### Waverley Borough Sections

Section	GCC Proposal	SCC comments	SCC est. cost	Timescale/ priority
---------	--------------	--------------	---------------	---------------------

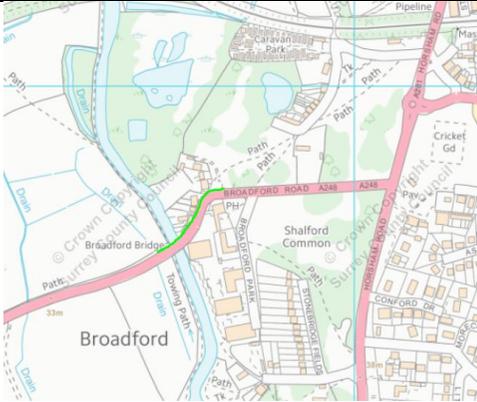
There is a low-lying section that can flood and accumulate sediment.

This stretch is a sub-standard width. Tree roots make aggressive speedbumps for cycles, buggies and wheelchairs.

Adjust the entrance to give level passage and clear priority to pedestrians and cyclists.

We agree that it is preferable for pedestrians and cyclists to have priority however this requires a site specific assessment involving Highways and Road Safety colleagues.

The issue of who has priority at side roads depends on the environment at that location and should be based on factors such as safety and visibility, and where the highest flows are (drivers or non-motorised users). Any changes need

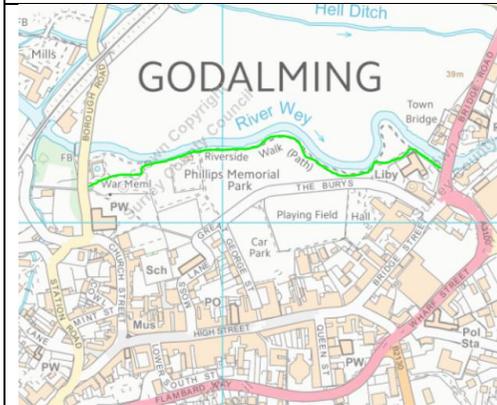
Bridge Street/Woolsack Way junction. There is currently only a refuge to assist crossing between Homebase and Bury Fields. It is a busy junction, designed to keep traffic moving quickly. People crossing the road must contend with traffic approaching from multiple directions.

Provide a shared use crossing.

This is a tricky area where the whole junction needs to be rethought out.

Congestion is a problem here too.

Maintenance cost will also be an issue.

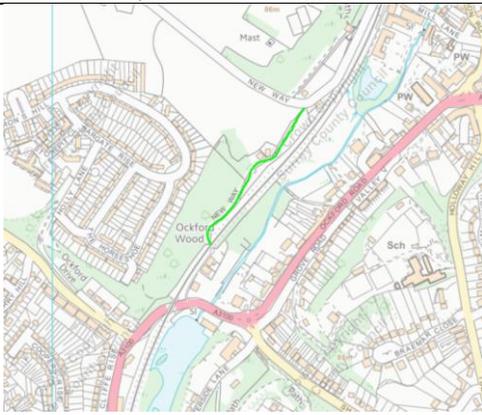
Provide appropriate signage. Also, where the path emerges from behind the bowls club pavilion, just to the north of the band-stand, some adjustments may be required to make the route clear.

Formalising this route may create issues, would need to be discussed further with WBC.

Will want to widen it in places but avoid mature trees.
